**TM-1461
(SSC-N-350)
1100.700**

**Checking the Numbers for the Labyrinths Shown
in the SSC Conceptual Design***

**J.D. Cossairt
Fermi National Accelerator Laboratory
P.O. Box 500, Batavia, Illinois 60510**

April 1987

Figure 6.6-4. Collider Ring Access Shaft plan view.

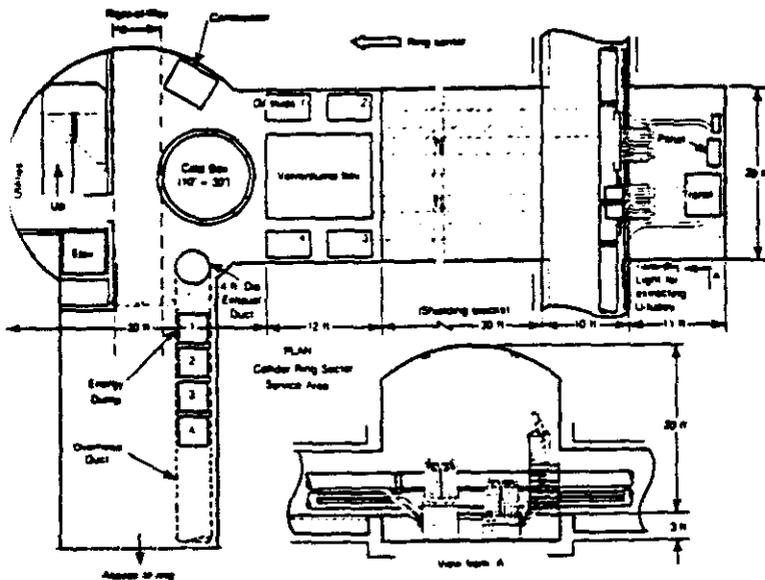
First consider the ring access shaft. I could not find this structure shown in its entirety in the report so I have had to guess what it might look like based upon the written description. The following sketch is an expression of my interpretation. It is to be noted that the length of the second "leg" has not been specified so I will end this discussion by making a suggestion.

The **first leg** has a cross sectional area of about $5.4 \times 5.4 \text{ m}^2$. Its length, according to my interpretation of the figures, is 17.3 m so that it is 3.2 "units" long. Consider the source to be a "line source", Figure 6 of (Go71) gives an attenuation factor of 0.25 for this leg.

Sections after the innermost were found by Gollon and Awschalom to be similarly effective for rectilinear labyrinths. Since the length of the second is presently unspecified, consider the **third section**. This leg, the vertical shaft, has a cross sectional area of 65 m^2 if one ignores any concrete structures which might be installed (likely to be thin and of limited shielding effectiveness). This means that a "unit" = 8 m. The length of this section, taking the shield over the ring to be the minimal 7 m, is only about 1.2 "units". Still, going around corners always helps and this leg, by the figure from (Go71) attenuates by a factor of 0.06.

The **second leg** must provide the remaining attenuation factor of 6.6×10^{-5} . From the figure, this will occur after 10 "units", or 54 m. These passageways can be made considerably shorter by making them smaller in cross section according to the scaling rules of Gollon.

Figure 6.7-1. Plan View of Type A Interaction Region showing collision hall, access way, shield doors, assembly area and Staging Building.

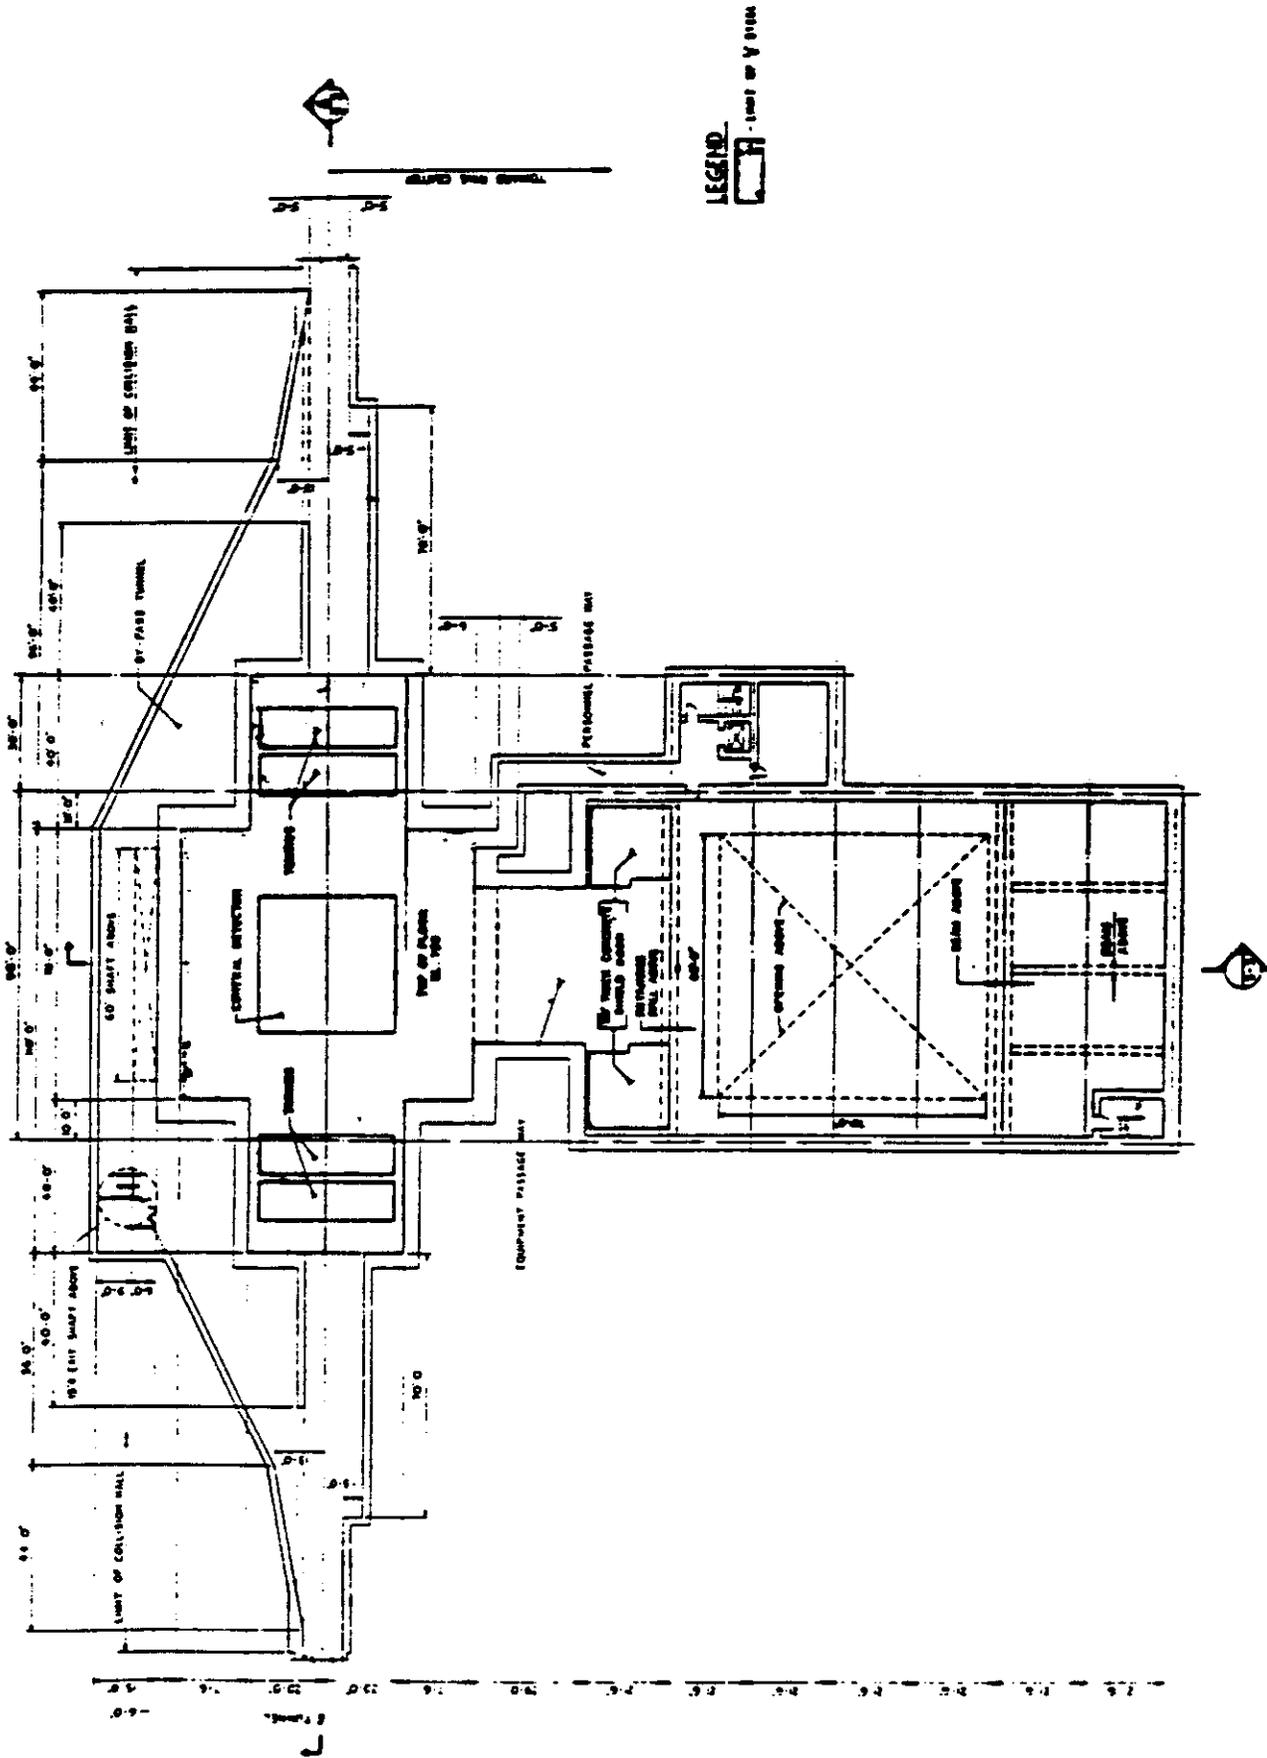
For a "Type A" Interaction Regions (both types being nearly the same for purposes of this discussion) the same procedure may be used. It should be noted that the "mouth" is 37.5' (11.4 m) from the nearest point to the beamline and 48' (14.6 m) from the intended vertex of the collisions. Having no better information, I have estimated that the cross-sectional dimensions of these passageways (which appear to be designed purely for people) to be 5' X 8' which implies a cross sectional area of 40 ft^2 . Thus $(A)^{1/2} = 6.3 \text{ ft}$ (1.9 m). Thus the **first leg** is about 1.4 "units" long. From Fig. 6 of Gollon's work, it is conservative to take the attenuation factor of this section to be 0.45. Continuing with the **second leg**, it is about 17 ft (5.2 m) long and hence approximately 2.7 "units". Thus the figure gives an approximate attenuation factor of 8×10^{-3} for the second leg. Going now to the **third leg** we find it to be 42 ft (12.8 m) and hence 6.7 "units". The

resulting attenuation factor may be read off as 4×10^{-4} . Thus the total attenuation for the three-legged labyrinth is 1.4×10^{-6} .

For this passageway there are two possible types of beam loss to consider. The first is accidental loss upon the beam pipe, a "fixed target" loss. To get an estimate of the source term again consult (Va87). In Figure 70 at a radius of 1.2 m a result of 2×10^{-7} mrem/proton is seen to be a maximum for a loss on a **bare beam pipe** of 20 TeV protons. If one supposes the collision hall to be empty, the loss of 1.3×10^{14} protons directly opposite the labyrinth would, invoking a $1/r$ dependence, produce a dose equivalent of

$$(1.2/11.4) \times (2 \times 10^{-7}) \times (1.3 \times 10^{14}) = 2.7 \times 10^6 \text{ mrem}$$

at the mouth of the labyrinth. Multiplying by the attenuation factor determined above would result in a dose equivalent of **3.8 mrem**. It is clearly unlikely that the interaction regions would ever be truly empty, or just contain a bare beam pipe. However, it is more likely that massive components would be in place which would reduce this dose by self-shielding. At any rate, such a catastrophic beam loss is unlikely to occur even as frequently as annually. This dose equivalent is therefore acceptable for such a controlled laboratory area.

The other type of loss is the steady loss due to the inelastic collisions of the 20 TeV protons. From Figure 144 of the work of Van Ginneken cited above, one finds a dose of 5×10^{-9} mrem/inelastic collision at a radius of 10 m from the vertex. This estimate is highly conservative due to the forward propagation of the particles from these collisions. Nevertheless, allowing for vertex to be in the wrong location (a highly surprising event to the accelerator physicists!) this is a somewhat useful maximum value. If we have, at $L = 10^{33}$, 9×10^7 collisions s^{-1} or 3×10^{11} h^{-1} , one would have a maximum dose rate at 10 meters of $1500 \text{ mrem } h^{-1}$. Multiplying by the attenuation calculated above results in a dose equivalent rate of $2.1 \text{ } \mu\text{rem } h^{-1}$ at the worst point. This is an entirely acceptable value.

Thus it appears that the design of the access penetrations is appropriate
